Crystal River Nuclear Plant
Docket No. 50-302
Operating License No. DPR-72

Subject: Crystal River Unit 3 – Response to Request for Additional Information on the Third 10-Year Inservice Inspection Interval Requests for Relief 09-001-II, 09-002-II and 09-003-II (TAC NO. ME0905, ME0906 and ME0907)

RESPONSE TO REQUEST FOR ADDITIONAL INFORMATION

Figure 12

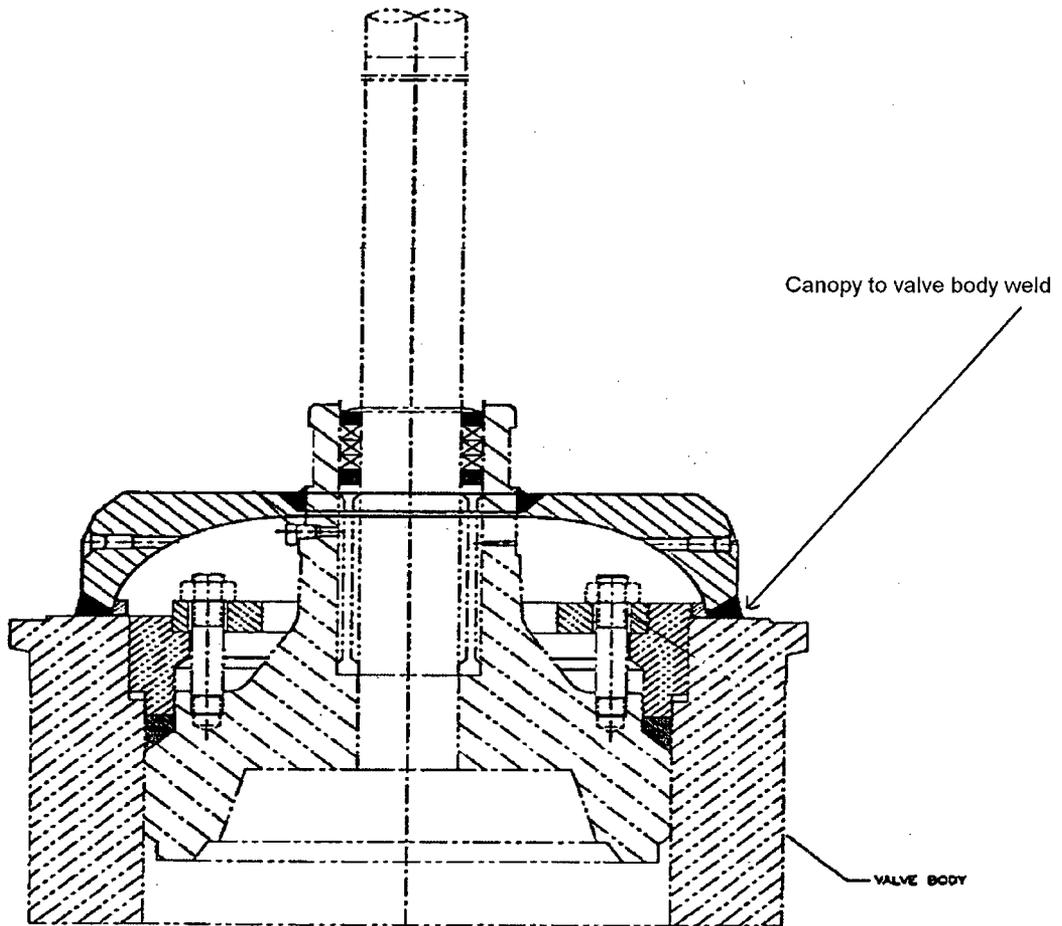
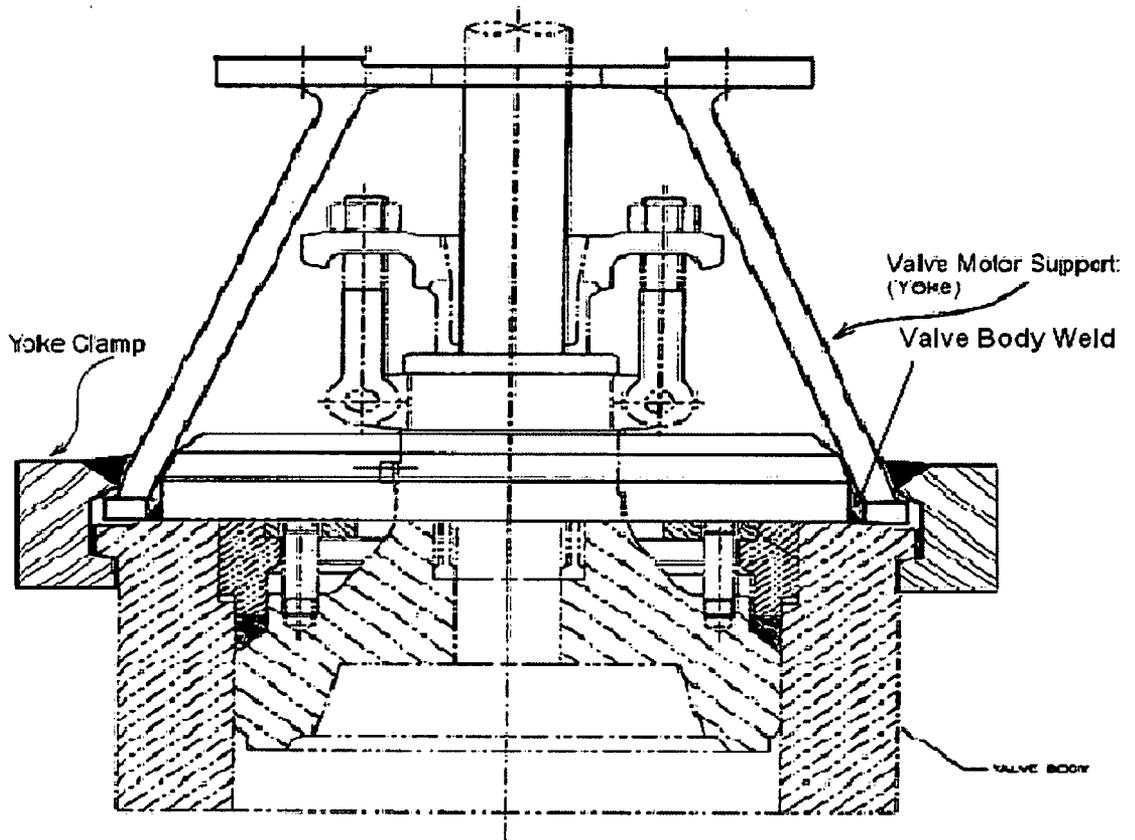
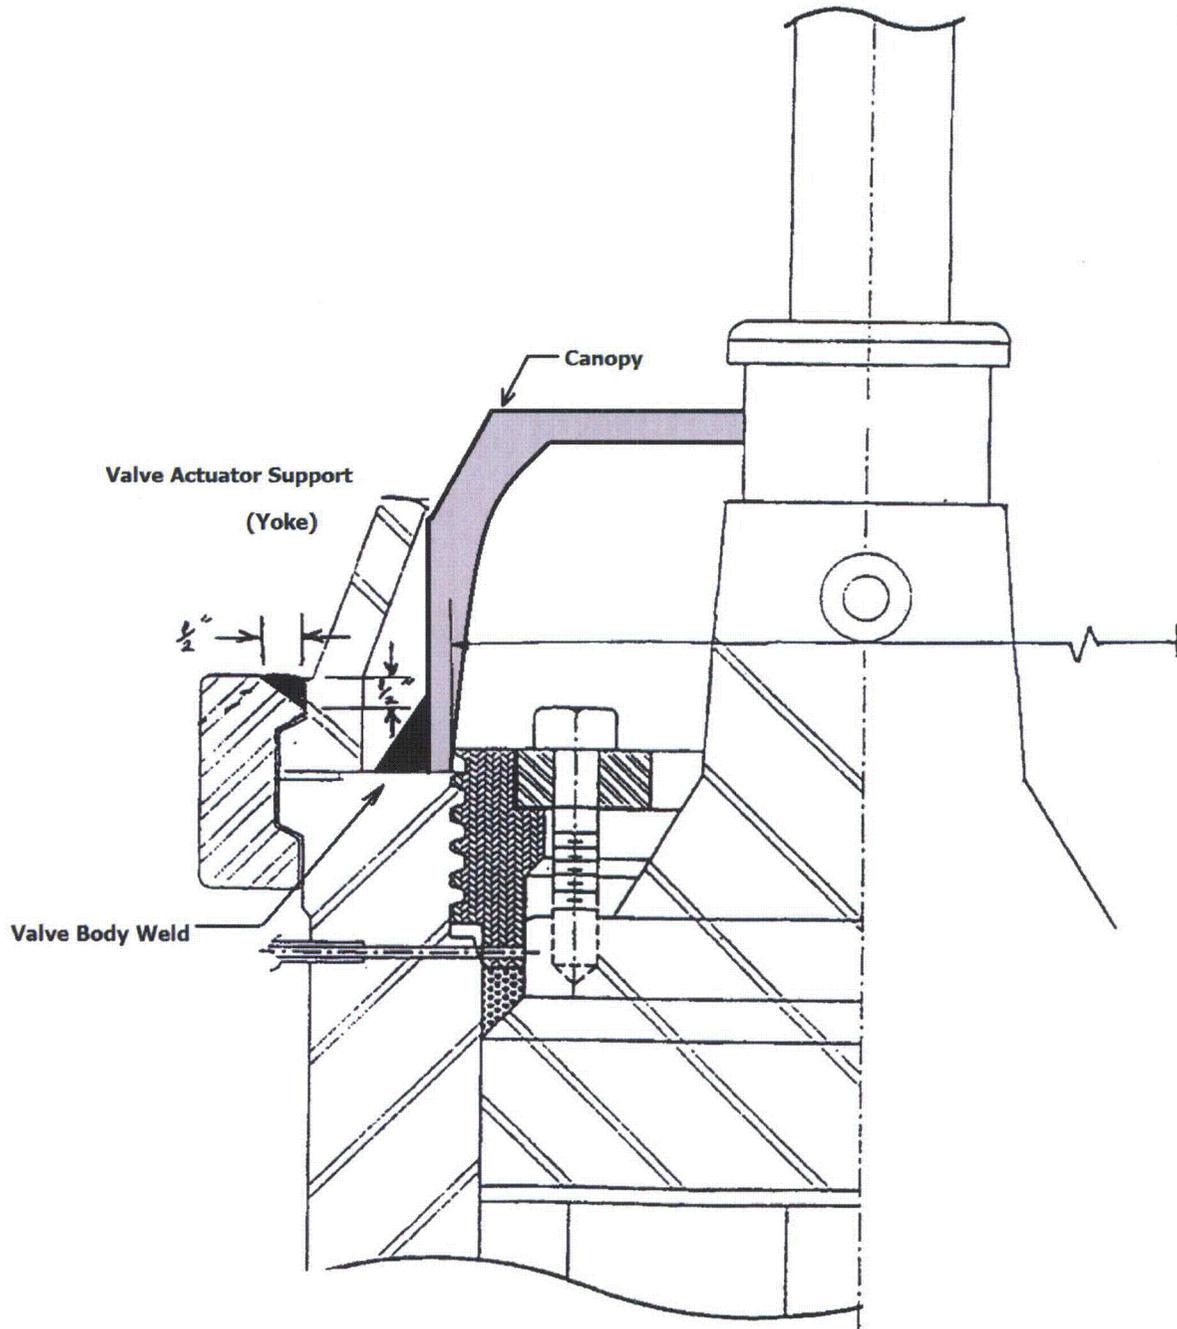
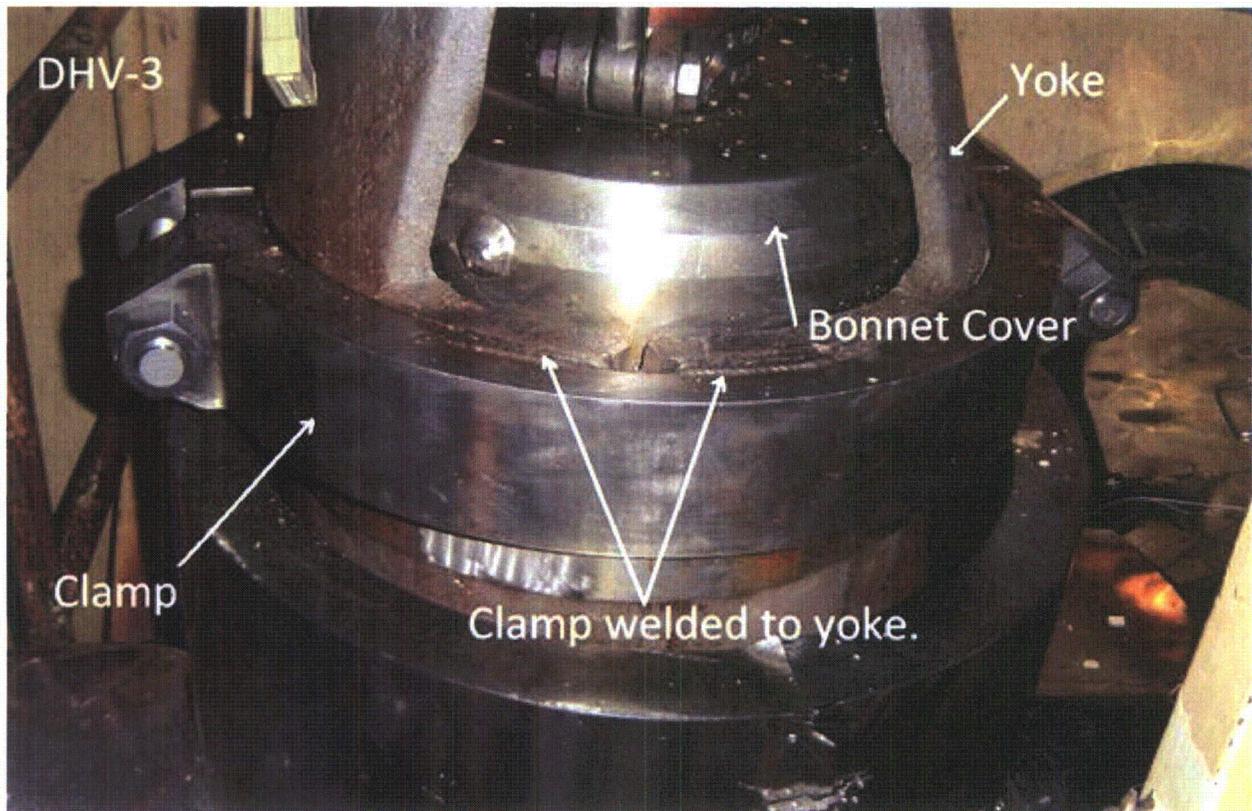
- 2.3.1 The licensee has not provided sufficient information to enable the staff to determine whether the subject valve body weld is inaccessible for volumetric examination. The licensee stated that the ultrasonic examination of the DHV-3 valve body weld would require disassembly of the valve to access the weld, however the drawings submitted in Attachment A of Enclosure 1 do not adequately display this weld, nor fully show access limitations. In addition, the provided drawings are unclear and difficult to read. Please submit clear diagrams/sketches of the valve and location of the subject weld, showing access restrictions that make disassembly of the valve necessary for volumetric examination.

The B-M-1 weld for valve DHV-3 is a limited single sided examination that is also inaccessible for volumetric examination without valve disassembly. Figure 12 shows the canopy-to-valve body configuration and weld without the yoke in place. The valve actuator support i.e., yoke, encompass the entire DHV-3 canopy-to-valve body weld (Figures 12 and 14). The valve actuator is seal welded to a mechanical clamp which is attached to the valve body (Figures 13 and 14). The examination of the B-M-1 after the yoke is removed would still result in a request for relief from the Code requirements since the examination of the weld is a single sided examination and the Code Required Volume coverage would be less than 90%.

DHV-3 is the first valve downstream of the reactor on the decay heat removal line and is in a high radiation area even when the reactor is de-fueled. This is the only B-M-1 category weld at CR-3. Removal of the yoke would involve extensive man-hours to

remove the yoke and its welded clamp, inspect the canopy weld, reinstall the yoke and re-weld the yoke to the clamp. The estimated time spent on the valve for removal, inspection, re-installation and post-maintenance testing is 100 man-hours, which would result in a total radiation exposure of 10R.

Figure 15

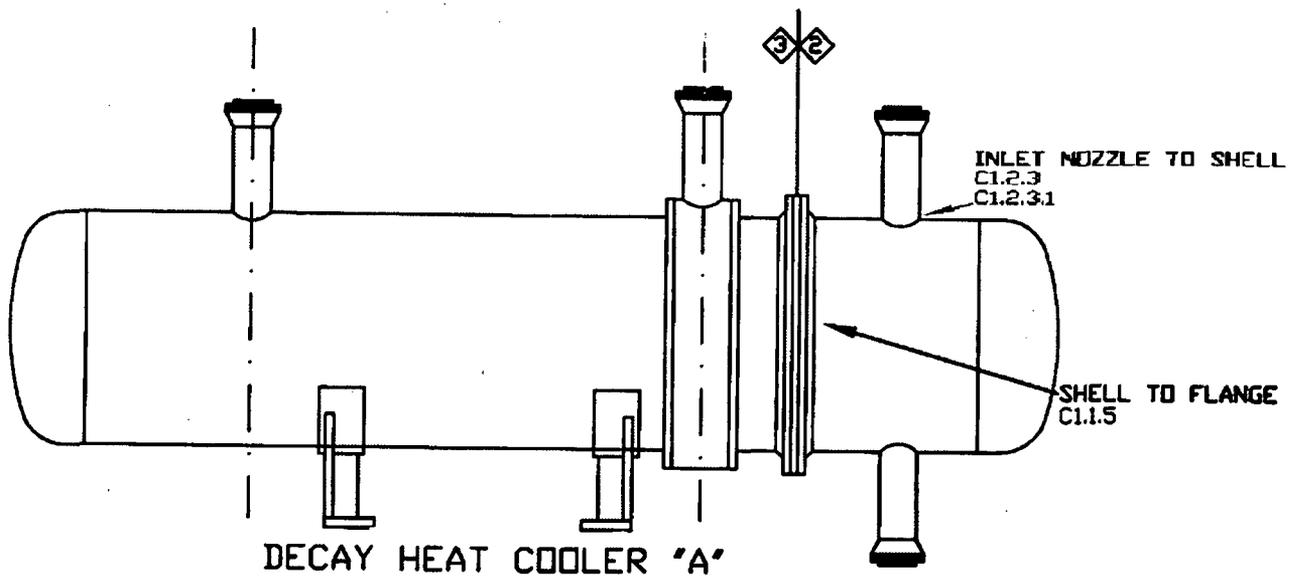
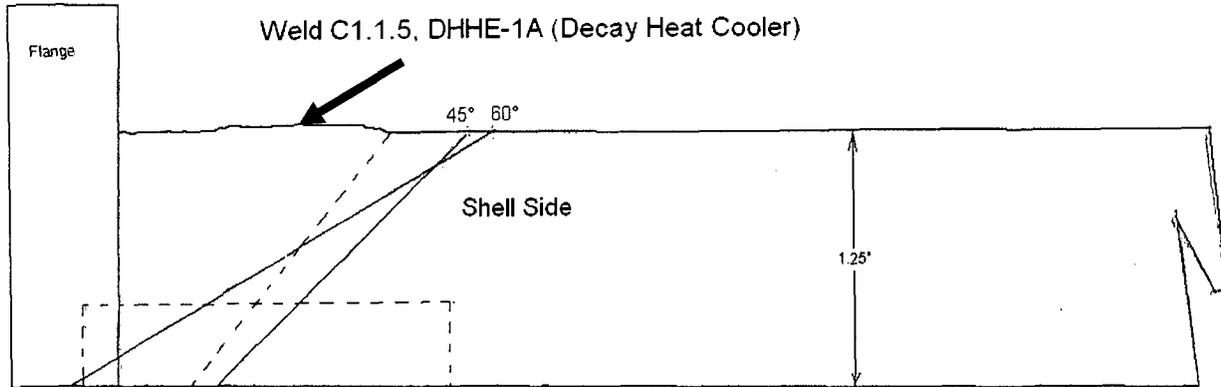
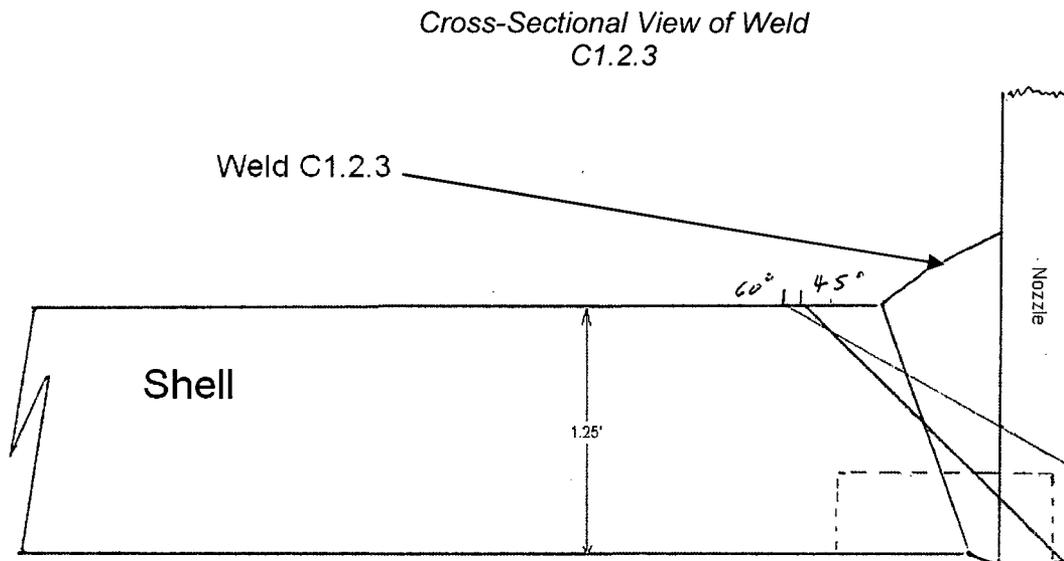
- 2.4.1 The coverage sketches included in the licensee's submittal do not contain dimensions and are not adequate to demonstrate impracticality for the subject volumetric examinations. Please clearly describe ASME Code Required Volumes and areas of completed coverage (including dimensions) that for clarification refers to the cross-sectional sketches. Summarize scanning directions and techniques used. In addition, list the base and weld materials, if not already provided. As applicable, describe NDE equipment (ultrasonic scanning apparatus), details of the listed obstructions (size, shape, proximity to the weld, etc.) to demonstrate accessibility limitations, and discuss whether alternative methods or advanced technologies could be employed to maximize ASME Code coverage.

Ultrasonic examination of the subject weld was limited in coverage due to component configuration and/or immovable physical barriers. It is not possible to perform a 100 percent ultrasonic examination from both sides of the weld since one side of the weld was not suitable for scanning based on the scanning surface angle of the component (flange). A single-sided examination for a stainless steel weld can only be credited for

The NDE techniques and procedures used incorporate examination techniques qualified in accordance with the ASME Section XI Code for examination of vessel welds less than 2 inches. The entire volume of this weld (Figure 15 for weld location) was interrogated ultrasonically; however, the qualified technique is only qualified to detect flaws on the examination side of the weld. No indications were identified for these examinations.

Ultrasonic examination of the subject weld was limited in coverage due to component configuration and/or immovable physical barriers. It is not possible to perform a 100 percent ultrasonic examination from both sides of the weld since scanning was performed on the shell side only (Figure 17). The scanning surface of the pipe is perpendicular to the shell surface which prohibits the ultrasonic wave entering the Code required examination volume at an angle that will integrate the weld volume for in-service flaws. Therefore, since the welds only received a single-sided examination, the resulting code coverage credit is less than 90% coverage of the required examination volume. The limitations were not due to excessive weld crown, diametrical weld shrinkage, or surface roughness conditions.

Figure 18

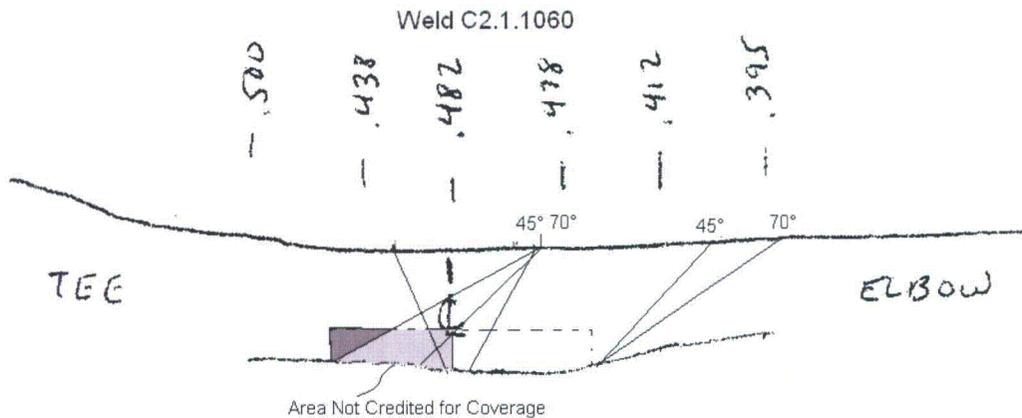
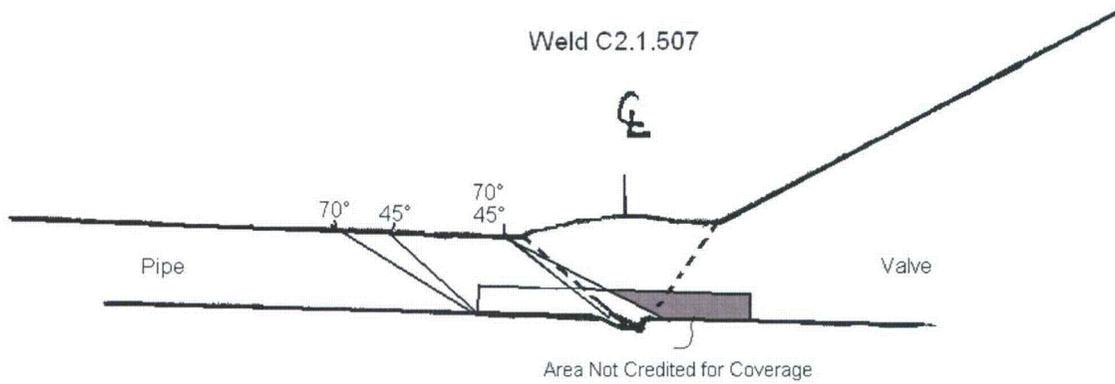
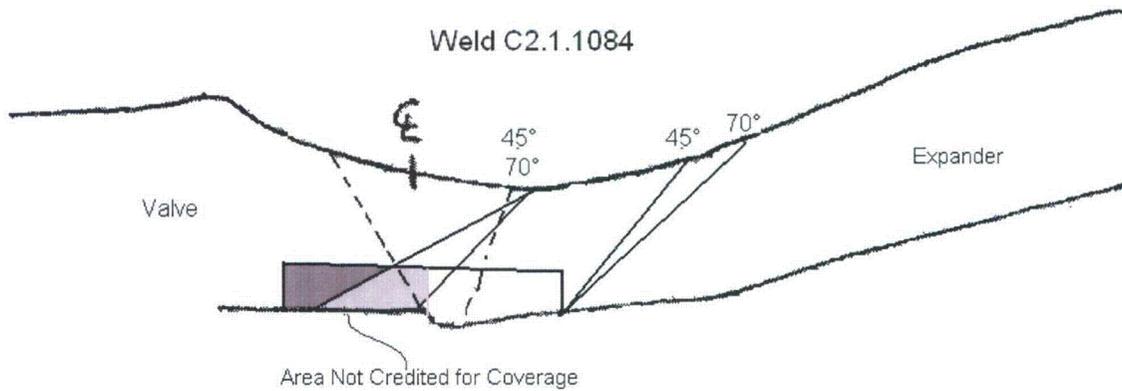
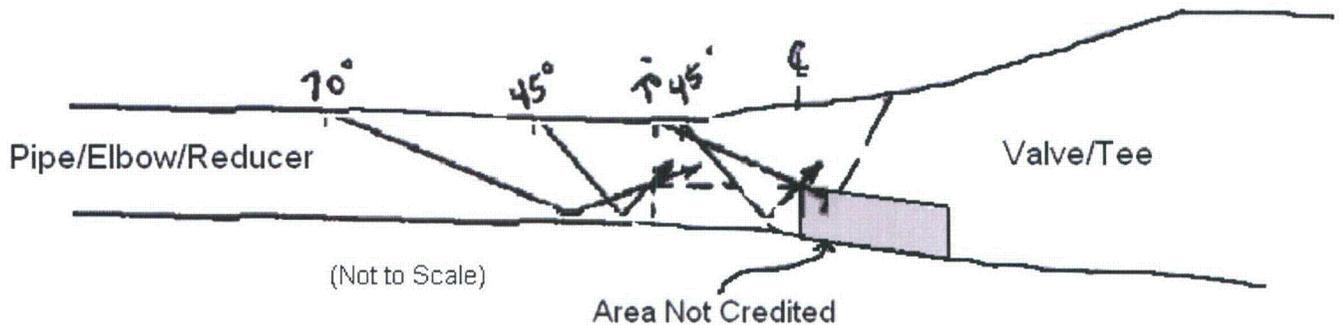
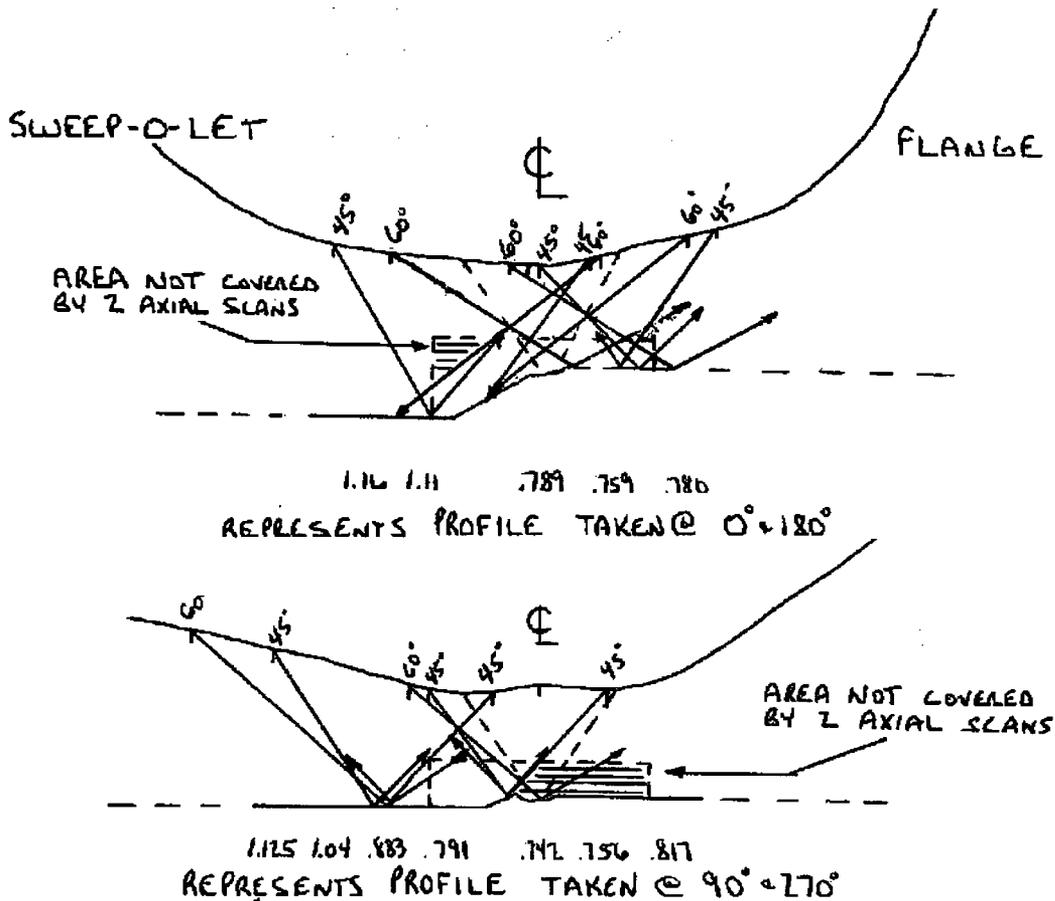
- 2.5.1 Provide further information to support the basis for each limited Examination Category C-F-1 and C-F-2 weld, and therefore, demonstrate impracticality. This information should include detailed descriptions (with sufficient explanation which may refer to the lay-out or cross-sectional drawings/sketches) to enable the staff to fully understand the causes of ultrasonic scan limitations and their impact on examination volume coverage.

elbow side: 45° and 70° shear wave scans perpendicular and parallel to the weld in one axial direction and two circumferential directions. For welds with a nominal thickness less than 0.500 inches, a 70° refracted longitudinal wave transducer was used to detect flaws parallel to the weld. Therefore, the welds only received a single-sided examination resulting in code coverage credit less than 90% coverage of the required examination volume. The actual coverage was 50% for single sided components (Figures 18, 19 and 20).

Regarding Examination Category C-F-2, Item C5.51, the ultrasonic examinations were limited in coverage due to component configuration, (Sweep-o-let to Flange). The welds were examined from both sides using the minimum and maximum scanning angles. The configuration limits access of the transducer for scanning. The examination coverage was based on the aggregate from manual scans of both sides: 45° and 70° shear wave scans perpendicular and parallel to the weld in two axial directions and two circumferential directions.

The majority of the C-F-1 welds do not have a specific Code Required Volume (CRV) sketch. The CRV sketches were not a Code requirement and therefore were not mandatory. The following sketches are typical for the reported configurations (Figures 21 and 22).
